Docket Number:	19-SB-100
Project Title:	SB 100 Joint Agency Report: Charting a path to a 100% Clean Energy Future
TN #:	236101
Document Title:	Gary C. Matteson Comments - Gary C Matteson Comments on Draft SB100 Joint Agency Report
Description:	N/A
Filer:	System
Organization:	Gary C. Matteson
Submitter Role:	Public
Submission Date:	12/22/2020 7:05:10 PM
Docketed Date:	12/23/2020

Gary C Matteson Comments on Draft SB100 Joint Agency Report

Re: Comments on the California Energy Commission Docket No.19-SB-100: Senate Bill 100 Draft Report Workshop

Figure 7: Final Energy Demand by Fuel Type in the High Electrification Scenario

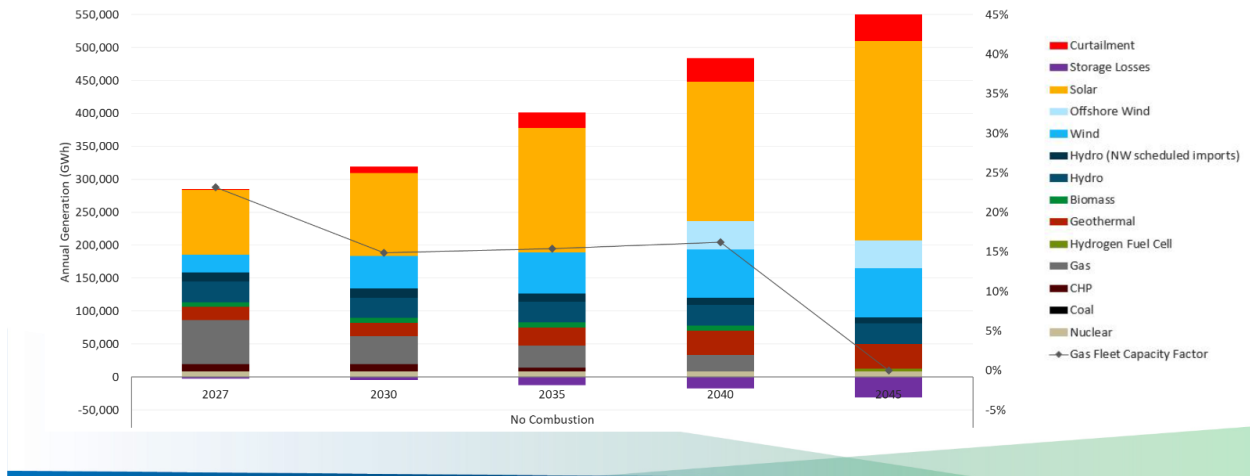
Though the draft *SB 100 Joint Agency Report* uses demand forecasts from the CEC's Deep Decarbonization in a High Renewables Future, which extends to 2050, Searching this CEC document, I find only a graph indicating the amount on "non-electric generation energy consumption" for California's energy out to 2050. See below:

This graph shows energy demand in EJ. One EJ is equivalent to .950 quads. Therefore, the demand for “non-electric generation energy consumption” goes from about 5.4 quads down to 2.8 quads in 2045.

Neither of the above graphs show the total energy sources required for 2045. My earlier work determined the level of energy sources to support California’s expanded population in 2040 to be 10.49 Quads and in 2050 to be 11.54 Quads. Source: G.C. Matteson, 2012, Energy Planning for Regional and National Needs, A Case Study- The California Forecast Chapter 5. The new economics Global Cases in Energy, Environment, and Climate Change. Springer ISBN 101461449715. pp 93. The forecast for USA by the US Energy Information Administration is 108 Quads for 2050. Source: US Energy Information Administration #AEO 2019, www.eia.gov/aeo pp 28. Given that California is about 10% of the nation’s energy consumption, this shows my 2040 and 2050 projections to be in the ball park.
